DEVIATION REQUEST AND DECISION FORM

Project Name :	Yucatan Convenience Store
Schedule No.(s) :	6501205016
Legal Description :	Lot 1 Clearview West Filing No. 2 (4815 Yucatan Dr. Colorado Springs, CO 80911)

EXHIBIT NOT TO SCALE

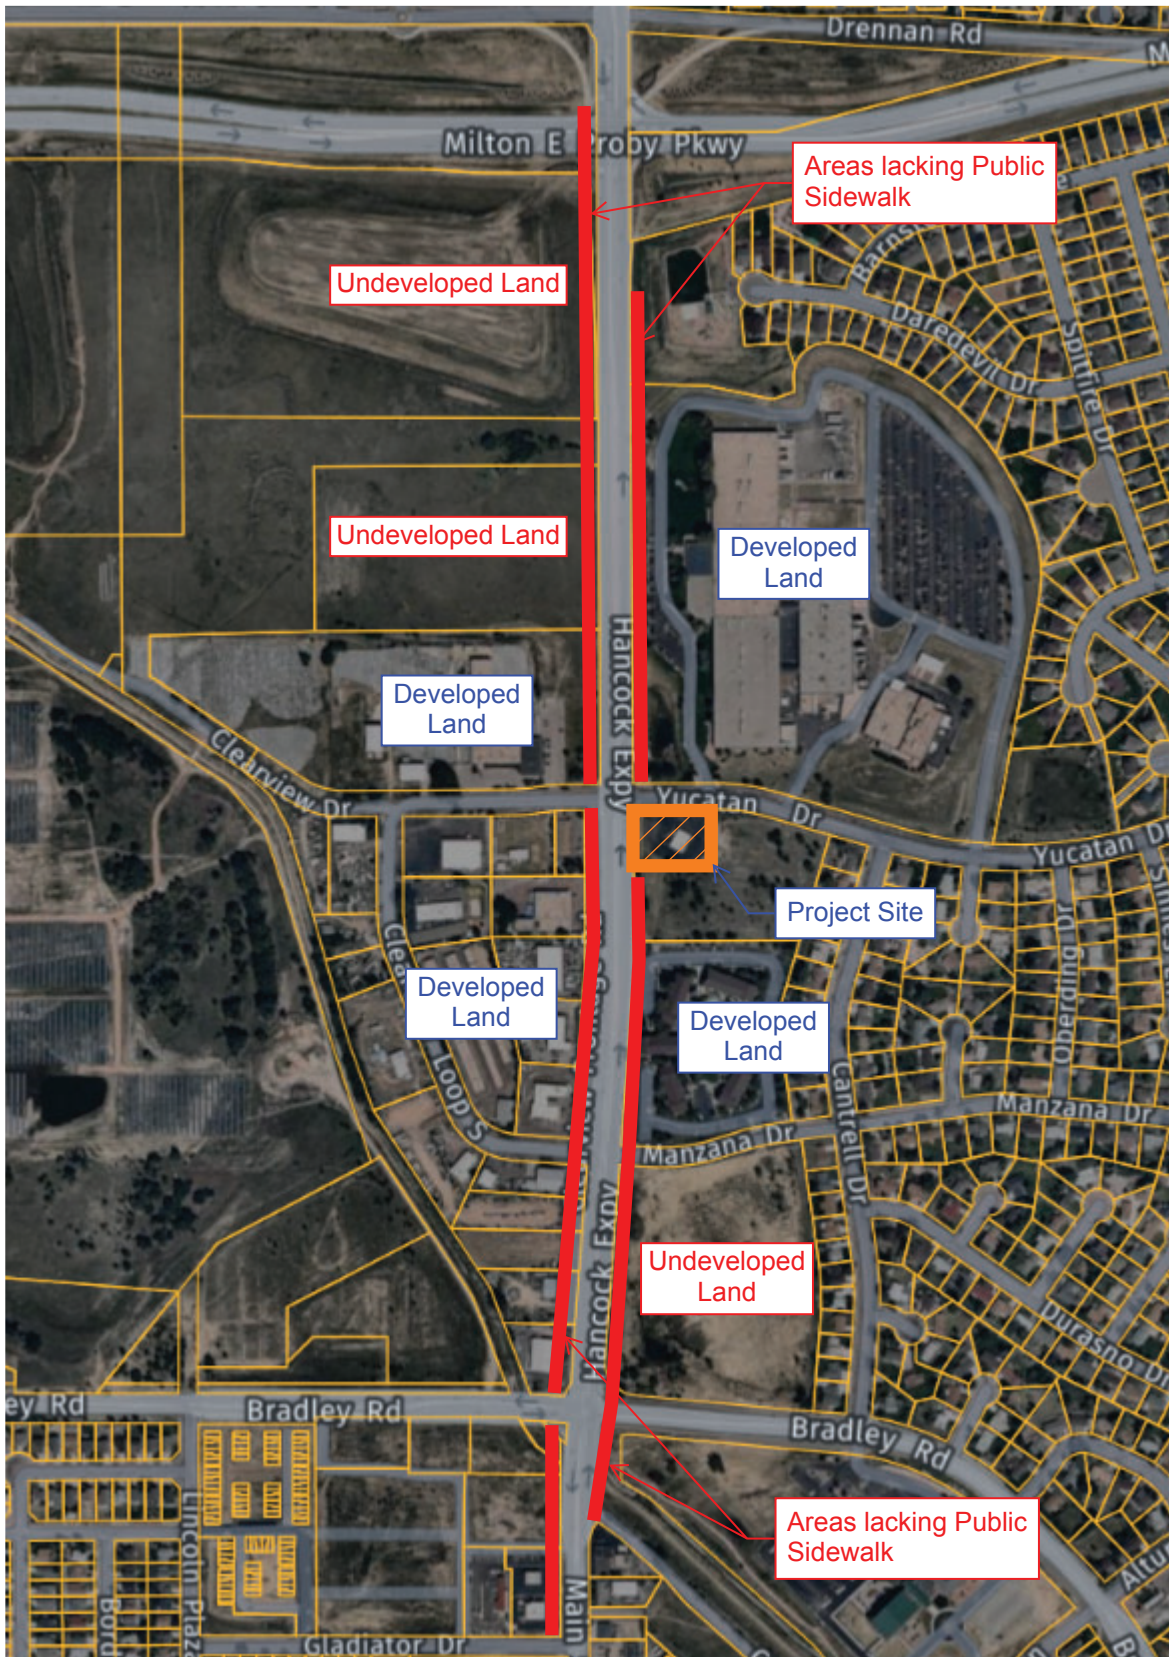
A different condition specific to the site must be identified.
